Petition Number: 2022-131

From: Jake Carpenter, PE Reviewer: Patrick Monroe

Date	Description		
12-29-22	First Review (PDM)

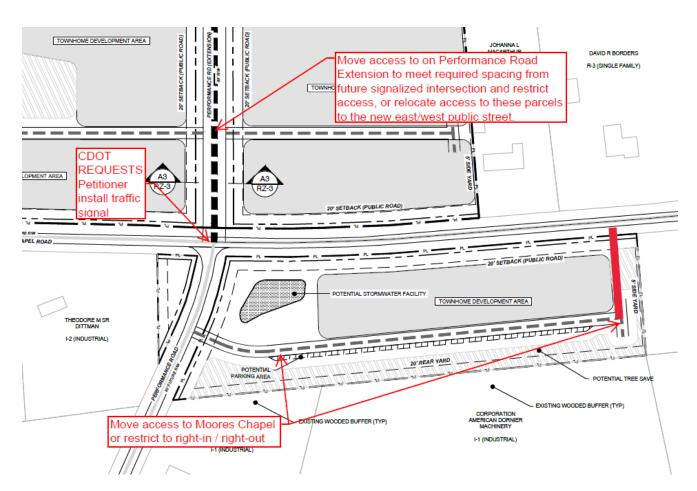
- 4. The proposed alignment of Performance Road extension does not match the approved CTP alignment of the road. Revise site plan to align Performance Road with the approved CTP alignment. If CTP alignment is to be amended, further coordination is necessary with CDOT.
- 5. Per coordination with NCDOT, revise site plan and conditional notes to provide an eastbound left turn lane and westbound right and left turn lanes on Moores Chapel Road at Performance Road with appropriate storage length and taper per NCDOT standards.
- 6. Per coordination with NCDOT, revise site plan and conditional notes to the proposed sight access per the markup below. CDOT and NCDOT anticipate a future traffic signal will be needed at the intersection of Moores Chapel Road and Performance Road, so access spacing / restriction requirements should be considered in relation to the future traffic signal.

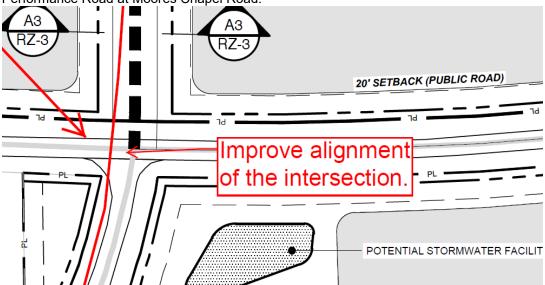
7. CDOT REQUESTS the petitioner revise site plan and conditional notes to provide a traffic signal at the intersection of Moores Chapel Road and Performance Road.

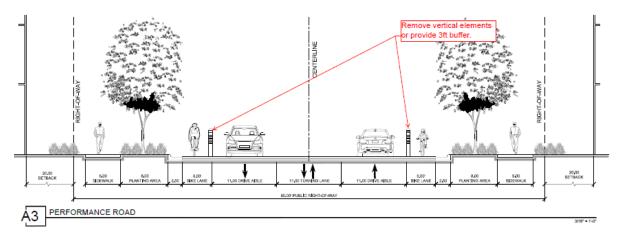
9. Revise site plan typical section of Performance Road to remove the vertical elements from the bike lane. If vertical elements are proposed, provide a 3ft buffer between the bike lane and vehicle lane.
